28 August 2024

K200826-4

**GEOTECHNICAL RESPONSE TO COUNCIL SECTION 92 REQUEST FOR FURTHER
INFORMATION - ADDITIONAL COMMENTS - BUN60406128 (LUC60406129, SUB60406160),
WAT60412104 & DIS60412103
PROPOSED SUBDIVISION - 2127 KAIPARA COAST HIGHWAY, MAKARAU**

Attachment B: WW-WW' Slope Stability Calculations

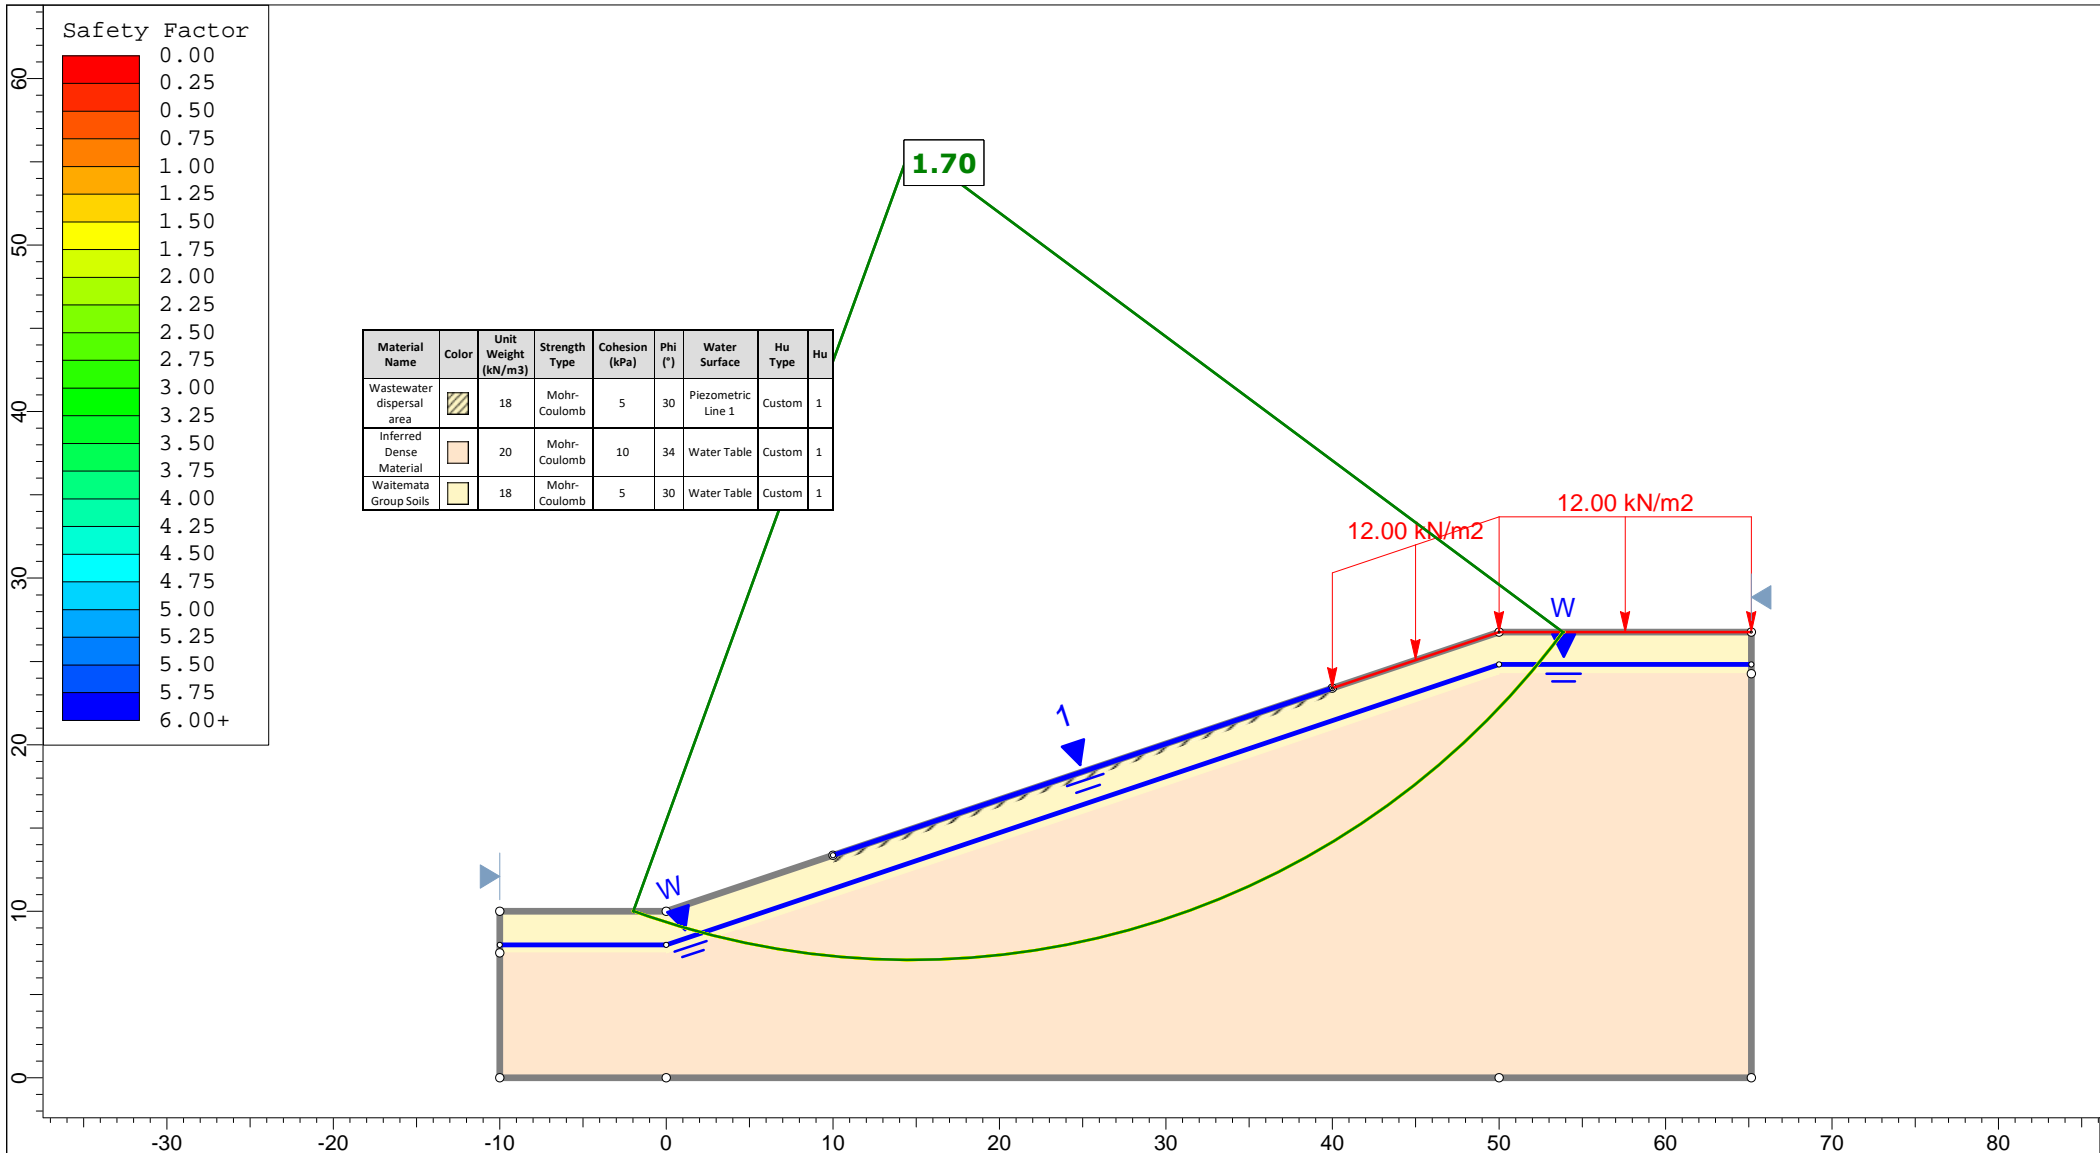
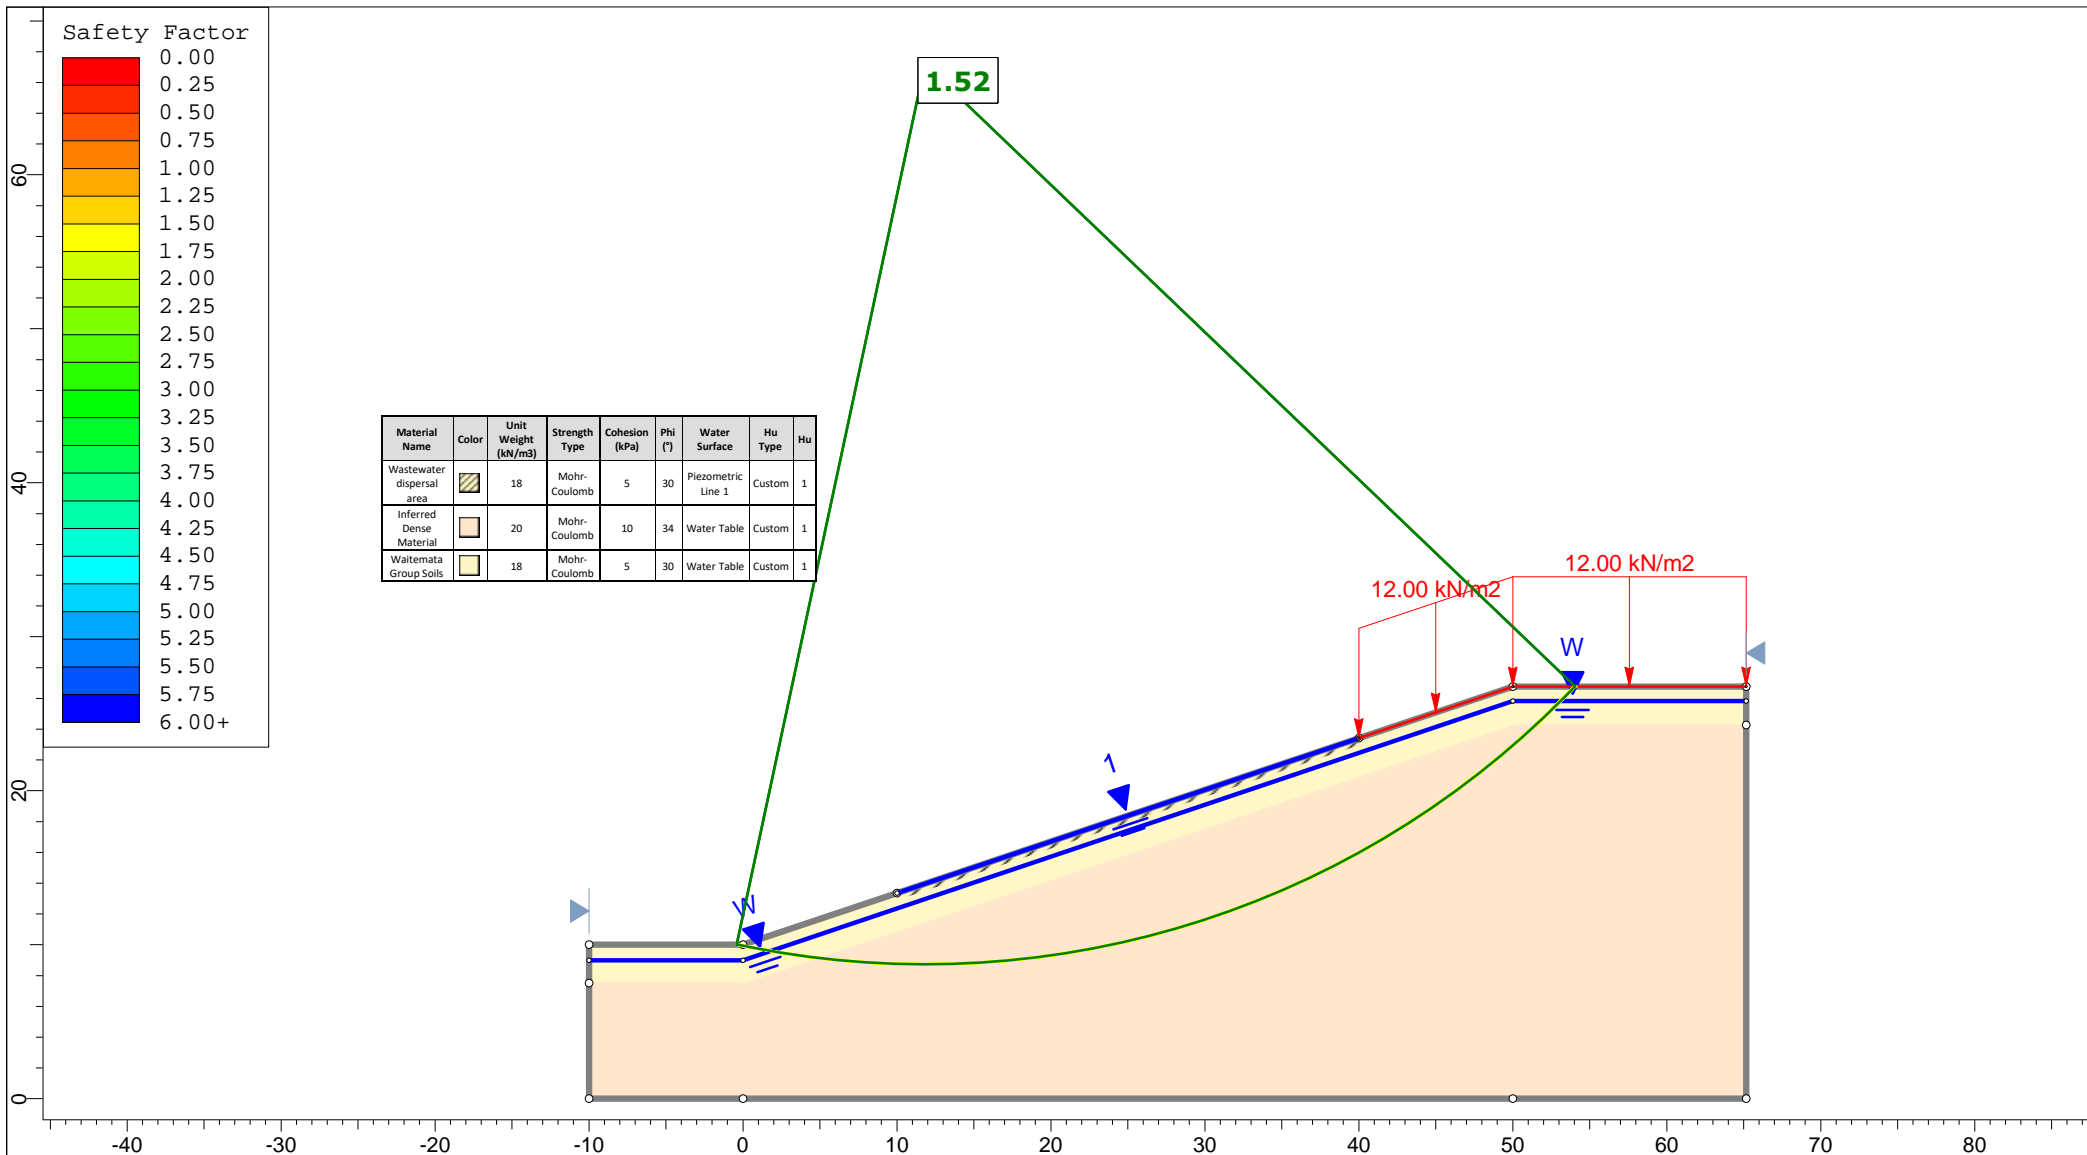
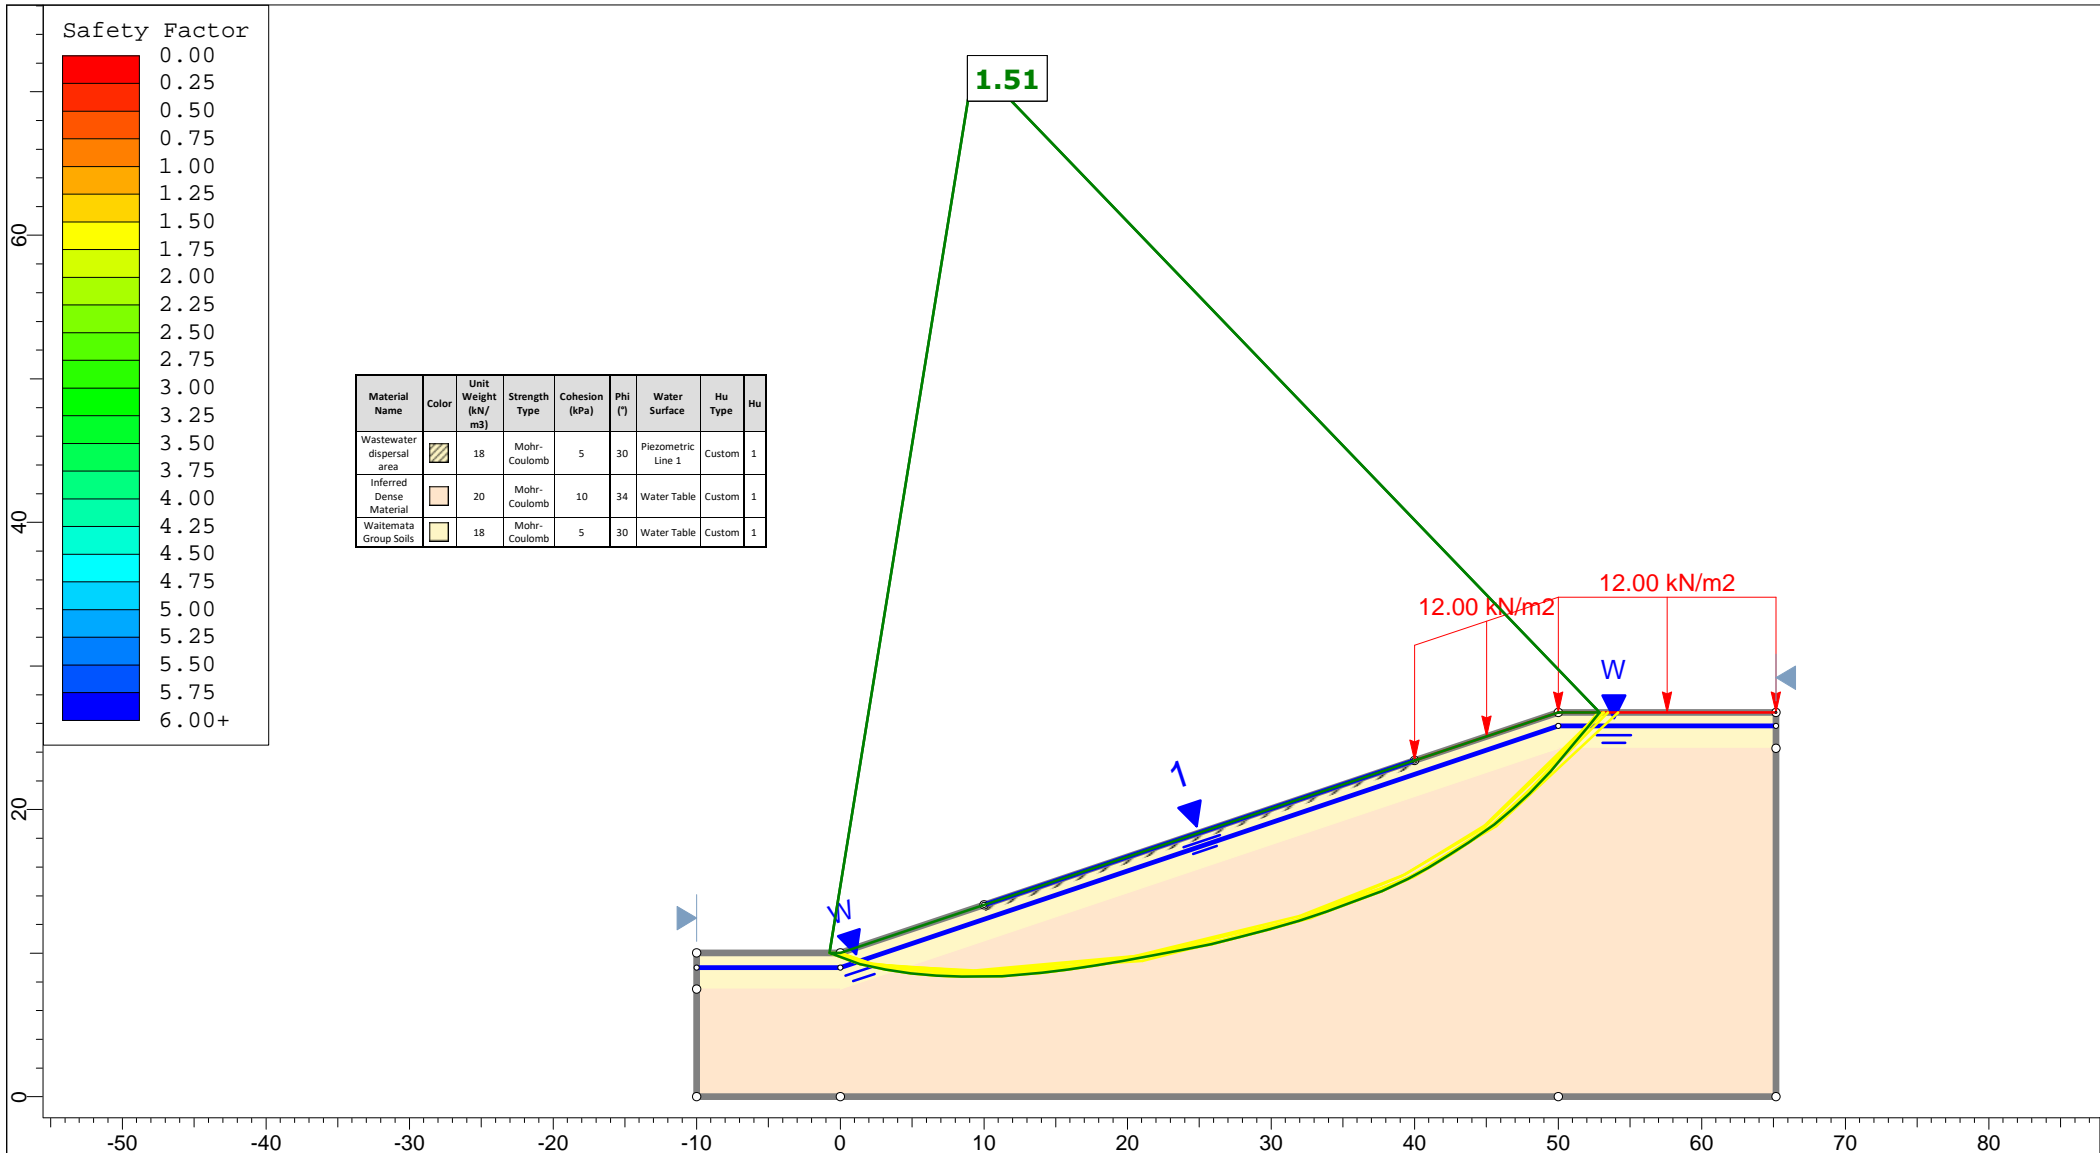
Council’s Specialist notes the wastewater disposal area is in the close vicinity of the proposed building platforms by the provided analysis are neither lot specific not considering surcharge load for a platform. Please clarify or revise analysis accordingly.

To reiterate the previous response, due to the scale of our global assessment, applying the potential dispersal areas to the entirety of the slope is not feasible due to the limited depth of affected soils comparative to the size/length of each model. Instead, a ‘worse case’ saturated upper slope scenario was assessed with a maximum gradient (1 vertical of 3 horizontal) to be encountered on the site.

The model has been updated to include a 12kPa surcharge upslope of the dispersal field to represent a potential building platform. A summary of the Factor of Safety results from the analyses is presented in Table 2 below. For detailed results, the slope stability calculation has been attached to the rear of this letter.

The results of the stability analyses indicate that the sloping ground with saturated upper 1.0m have acceptable Factor of Safety results for all conditions in accordance with “Auckland Code of Practice for Land Development and Subdivision, Chapter 2: Earthworks and Geotechnical”, July 2022. As such, as a preliminary assessment we considered the proposed wastewater dispersal areas feasible. This model is a proof-of-concept and is carried out to show dispersal is feasible on the sloping ground.
